22 Oct 96

Joseph J. Holonich, Chief  
Chief, High-Level Waste and Uranium Recovery Projects Branch  
Division of Waste Management  
Office of Nuclear Material Safety and Safeguards  
Mail Stop TWFN 7J-9  
U.S. Nuclear Regulatory Commission  
Washington, D.C. 20555

Re: Evaluation of Potential Surface Deformation Related to Salt-Dissolution Subsidence  
at the Atlas Tailings Site, Moab, UT, 8 Jul 96, Woodward-Clyde Federal Services.

Figure A.

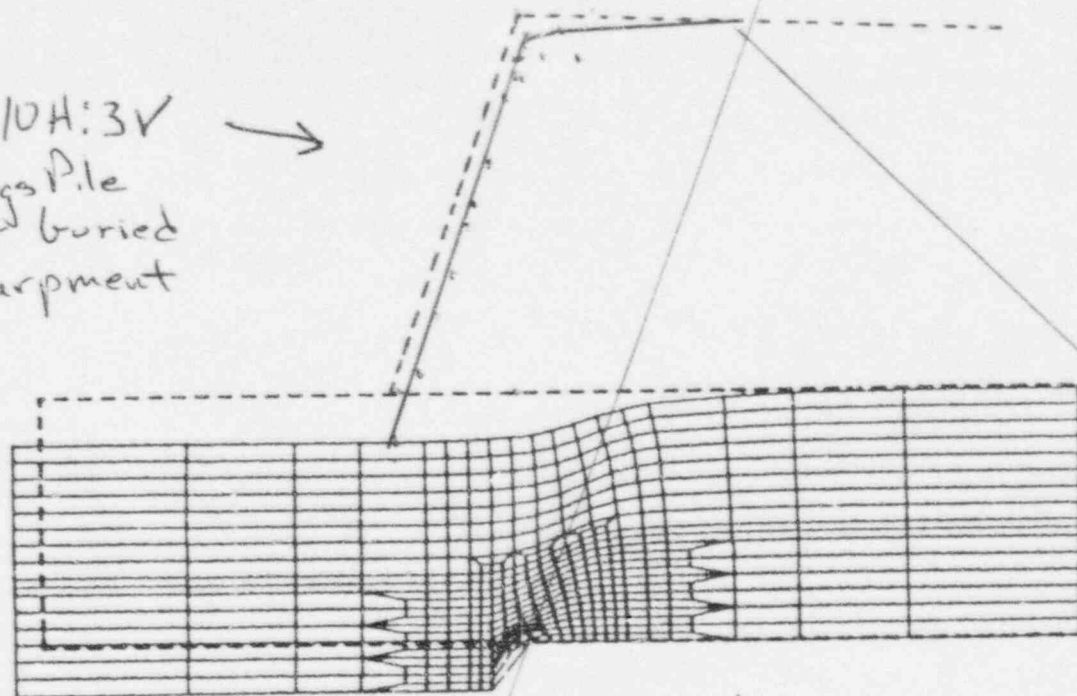
- a.) The Bray analysis described is for modeling fault rupture propagation through clays, not alluvium and tailings.
- b.) The tailings pile nonlinear stress-strain behavior was not adequately modeled. Averaging 17 samples is not characteristic of the Atlas tailings site. The range for coarse tailings is 3.35 to 19.47 among 7 bore holes. Triaxial compression tests are not

representative for the Atlas site because of the unconstrained free face of the the tailings pile with minimal lateral confining forces. (see attached figure A) The Bray model would be more applicable to subgrade disposal.

FIG. 7. Path of Normal Fault Rupture through Soil: (a) Stiff Earth Materials, Steep Dip; (b) Stiff Earth Materials, Shallow Dip; (c) Ductile Earth Materials

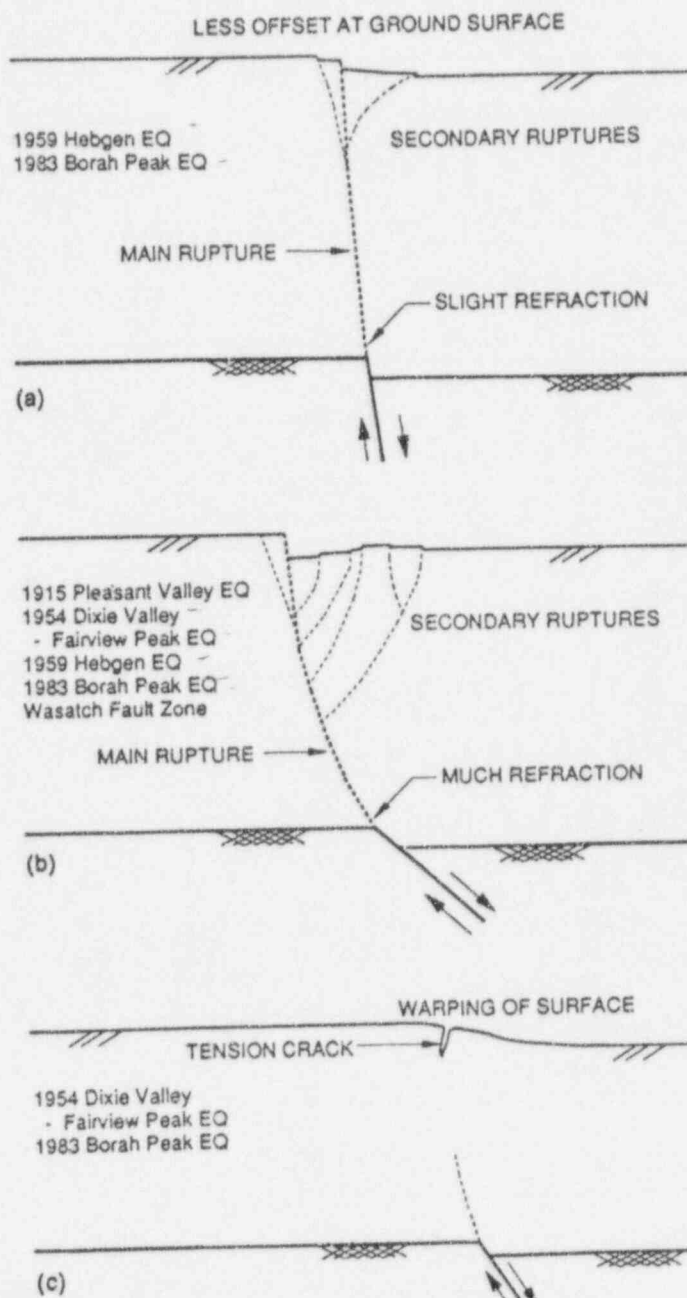
e.) The angle of dip of the fault plane is important to the corresponding area of surface displacement. What is the angle of dip of the fault plane at the Atlas site? (see Bray fig.7)
